BASE DOCUMENT: X-330-7302-M, REV. 0 CAD OVERLAY

DRAWING TITLE
PROCESS VENTILATION
BUILDING X-330
OPERATING FLOOR - PART PLAN

PROJECT
CASCADE UPGRATING PROGRAM
PORTSMOUTH, OHIO

DRAWING NUMBER
X-330-7302-M

OPERATING FLOOR PART PLAN
HEATING AND VENTILATING
SCALE: 1/8" = 1'-0"
FIN FL. EL. = 672'-0"

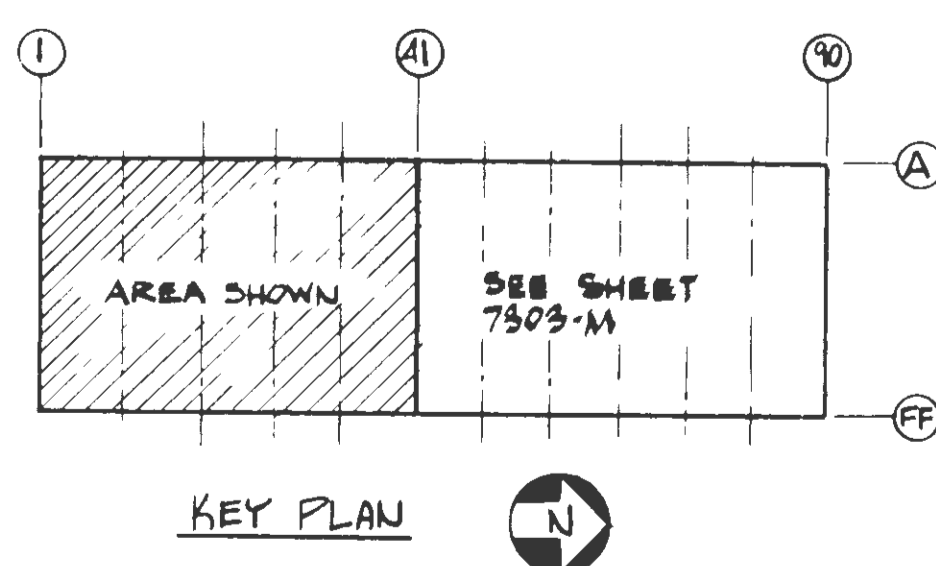
DEMOLITION NOTE:

1. VENTILATION TO BE REMOVED UNDER TSCA SPECIFICATION 40 CFR 761.61 (9)(3)(C). CAPPING WILL UTILIZE 18 GA. GALVANIZED PLATE, SELF-TAPPING SCREWS, HIGH-TEMPERATURE SILICONE SEALANT.
2. FILTER ROOMS 2, 3, AND 4 ON THE WEST WALL AND FILTER ROOM 19 ON THE EAST WALL ARE TO BE REMOVED AND FILLED IN.
